REVIEW OF THE 900 MWE REACTOR FLEET (VD4-900)

Expert Statement on the Generic Phase

By Order of the Federal Ministry for Sustainability and Tourism
Directorate I/6 General Coordination of Nuclear Affairs
BMNT: BMNT-UW.1.1.2/0019-I/6/2018

Figure 4:
Envisaged modifications
to avoid concrete
basemat melt-through.

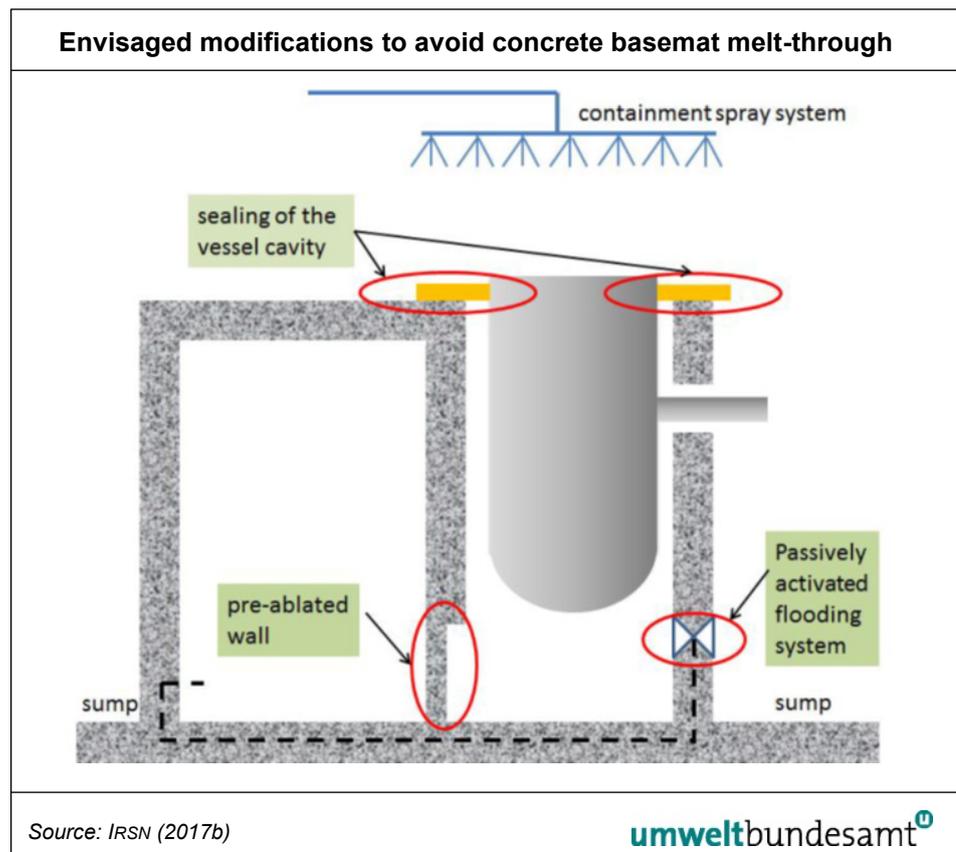
After the review of the principle of these modifications, IRSN has highlighted that this strategy reduces significantly the possibility of containment failure by steam explosion in a flooded vessel cavity and is a good compromise between efficiency and feasibility for the ex-vessel corium stabilization.

Figure 5:
Containment heat
removal disposal
(preliminary).

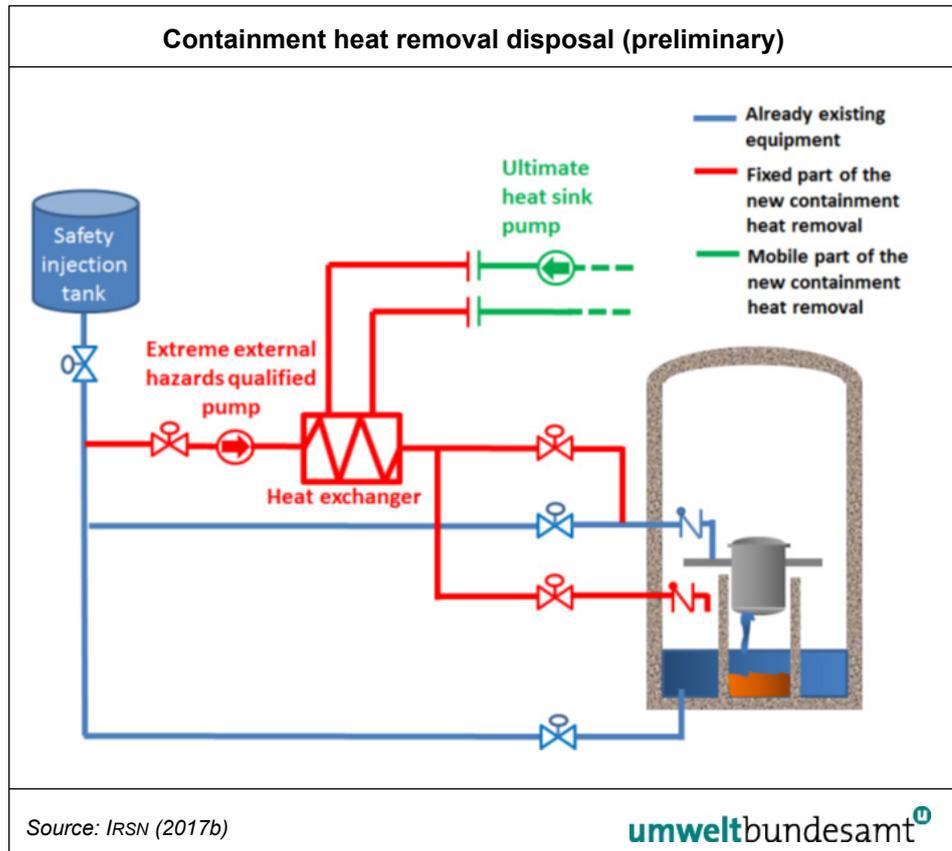
After the review of the principle of this modification, IRSN has concluded that the new disposal intended by EDF is satisfactory in principle and should enable to remove the decay heat from the containment. However, a lot of issues have to be resolved:
